CITY PLAN COMMISSION STAFF REPORT

LivSmart Studios KCI

CD-CPC-2024-00019

Non-Residential Development Plan

3 DUMPSTER ENCLOSURE
1/4" = 1'-0"

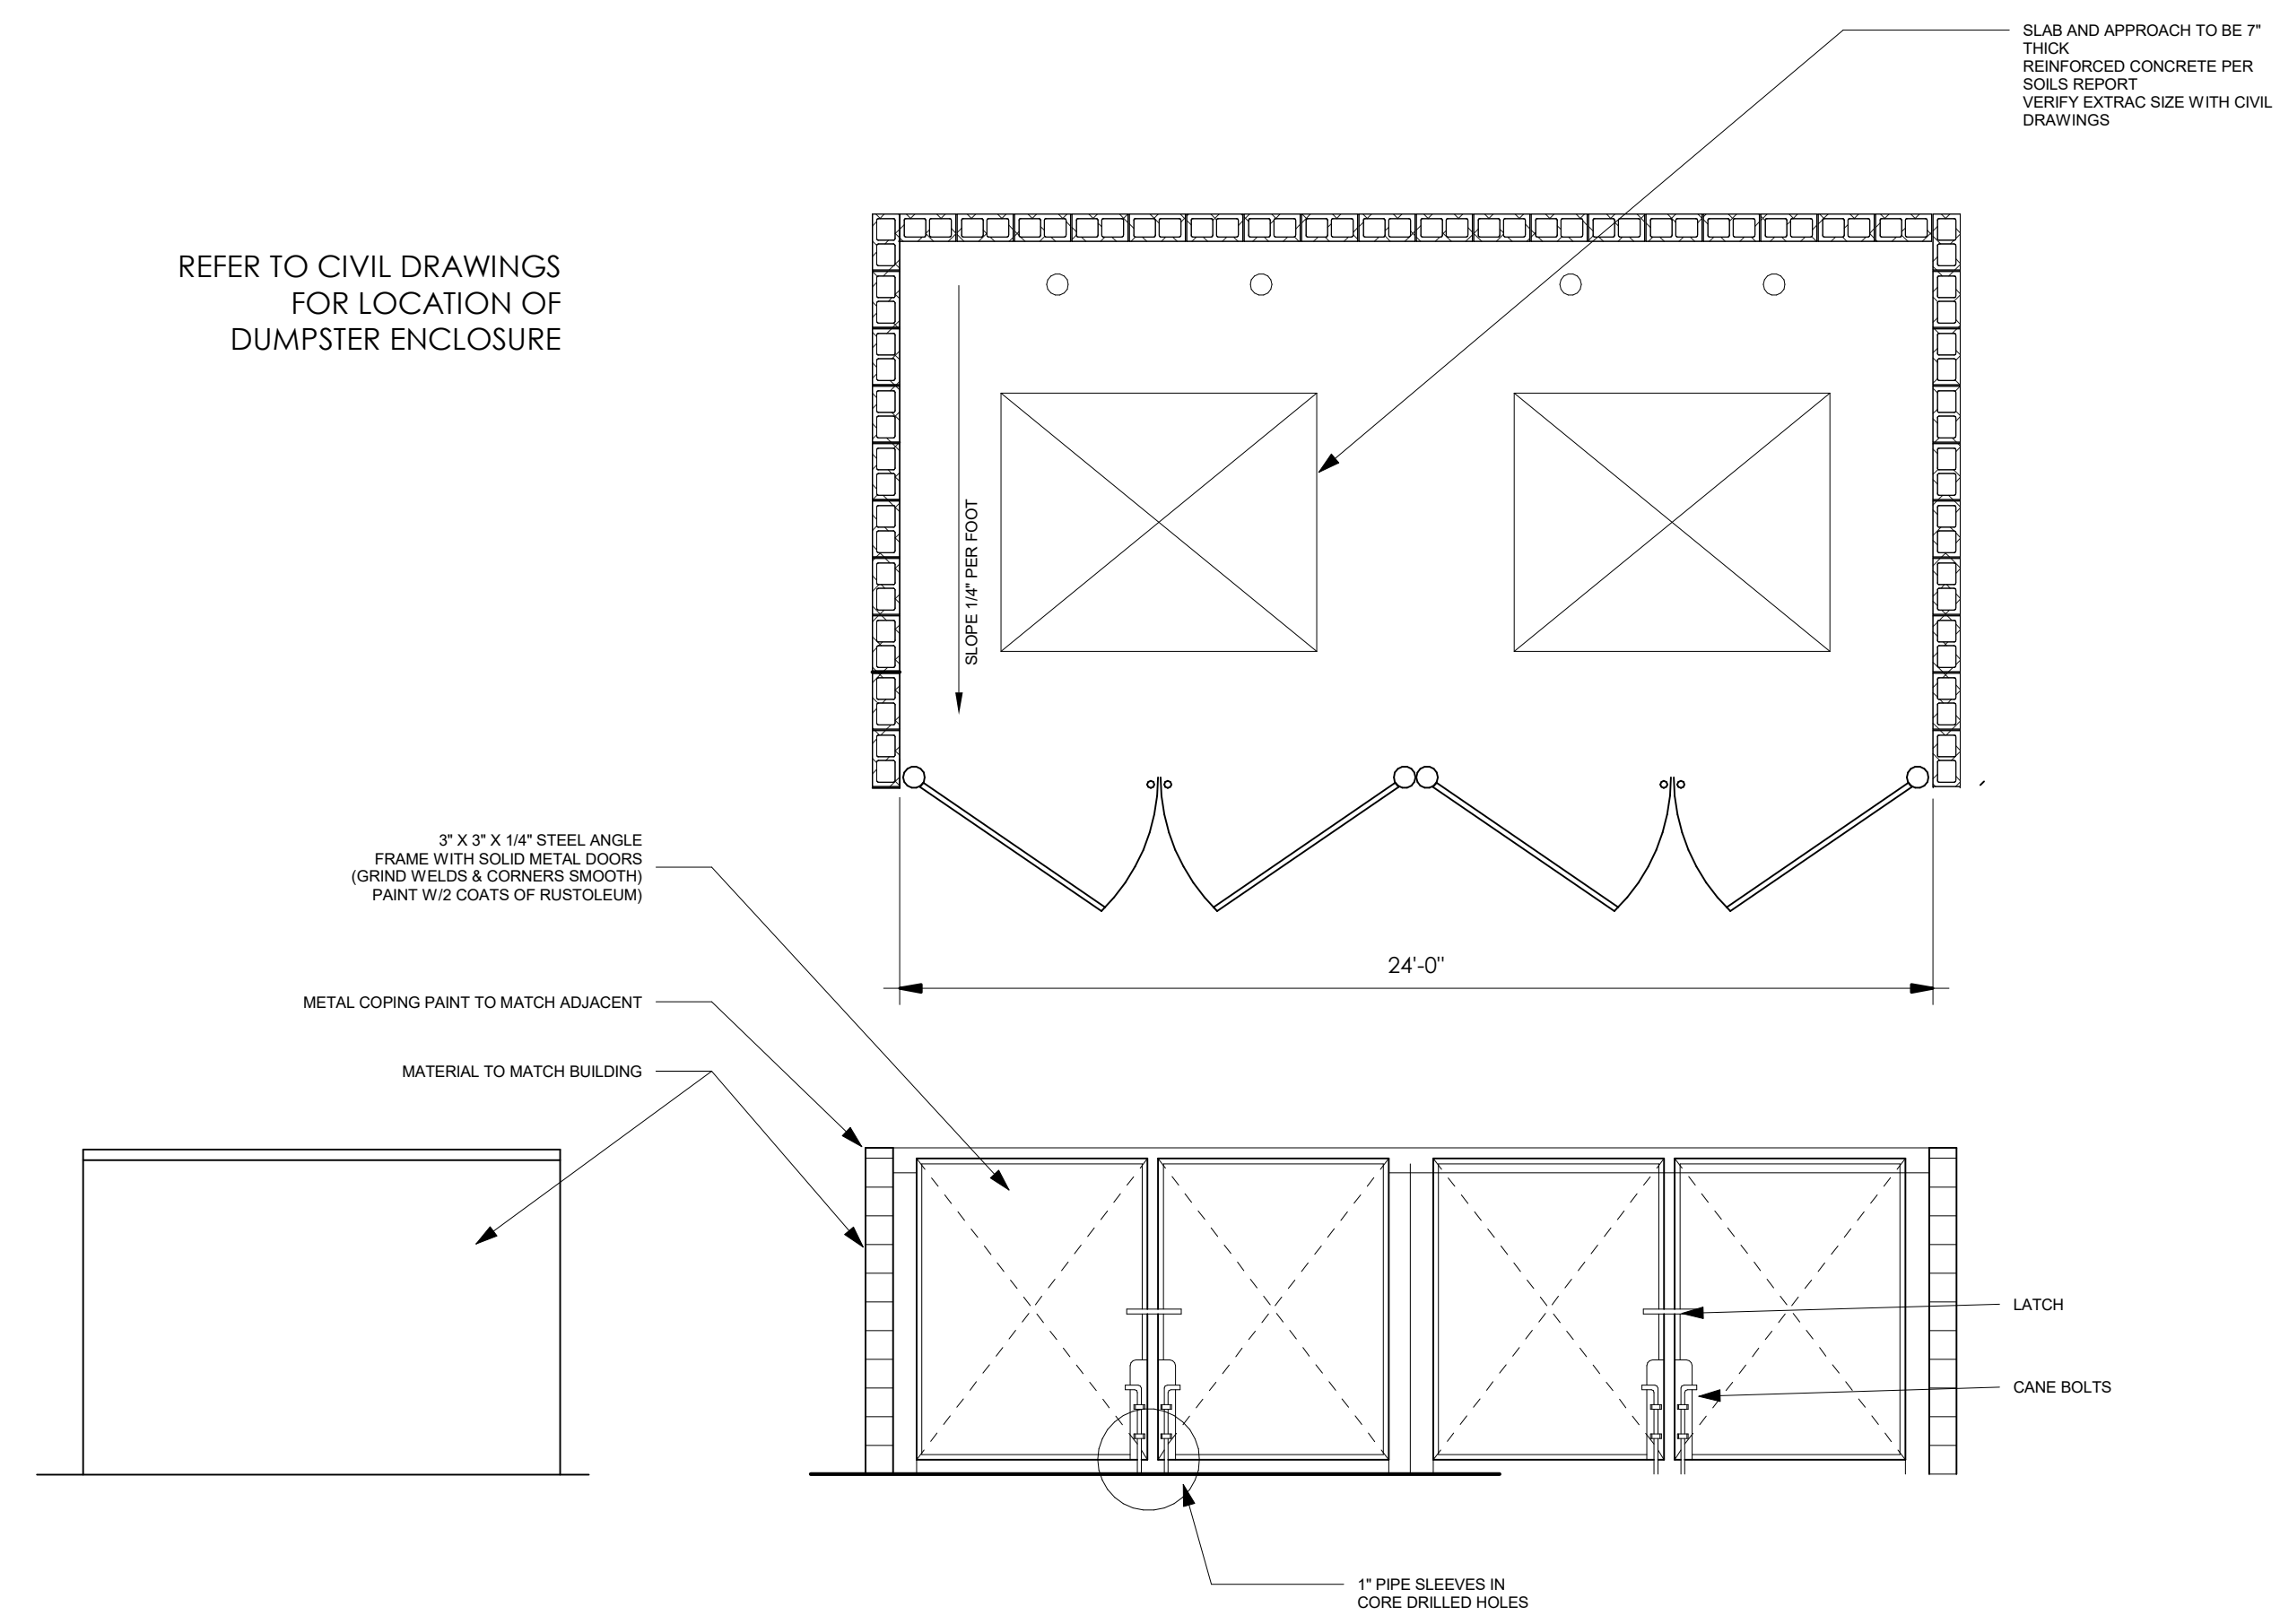
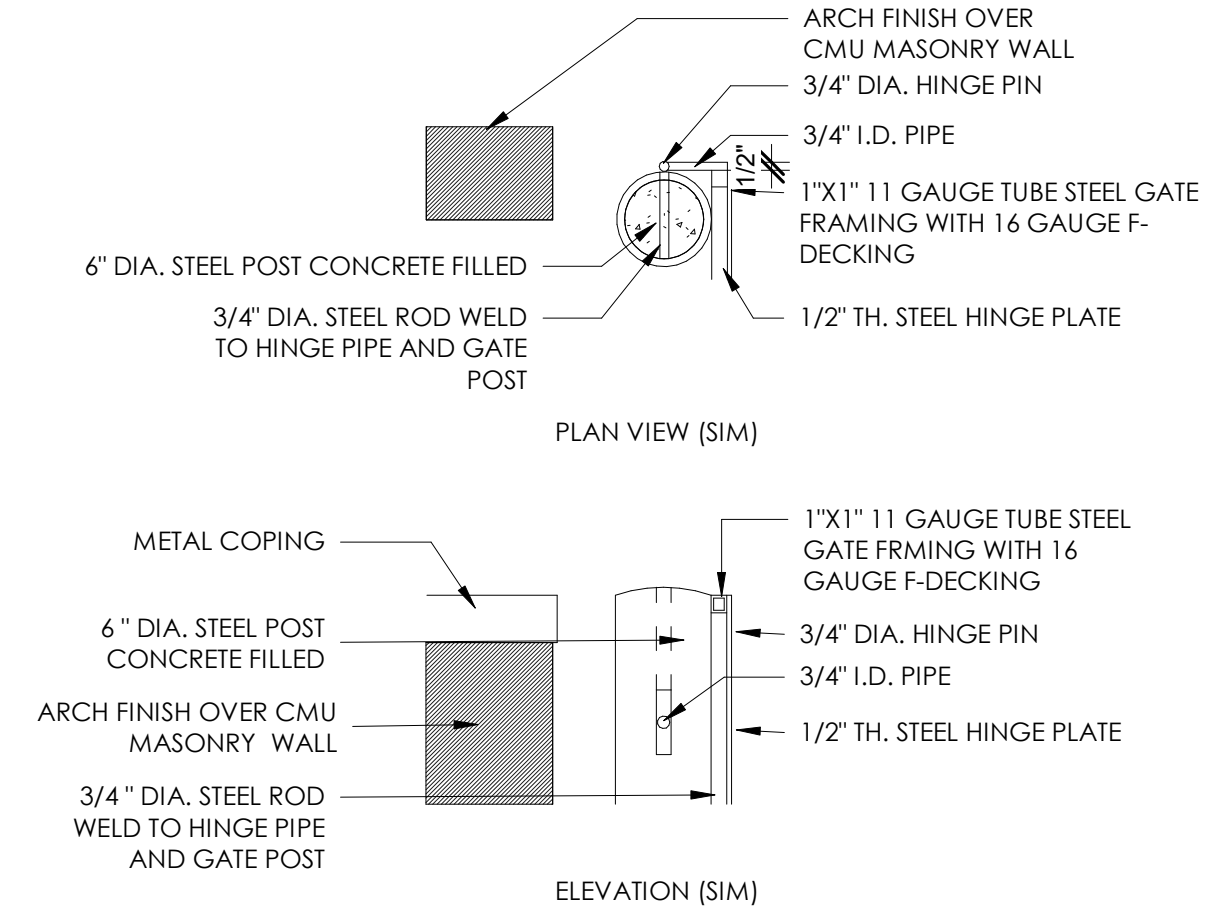
- b. Confirm addressing location on proposed structures.
 - c. Dumpster screening needs to be raised 6 inches to 1 foot from the ground on at least one side if solid screening materials are proposed.
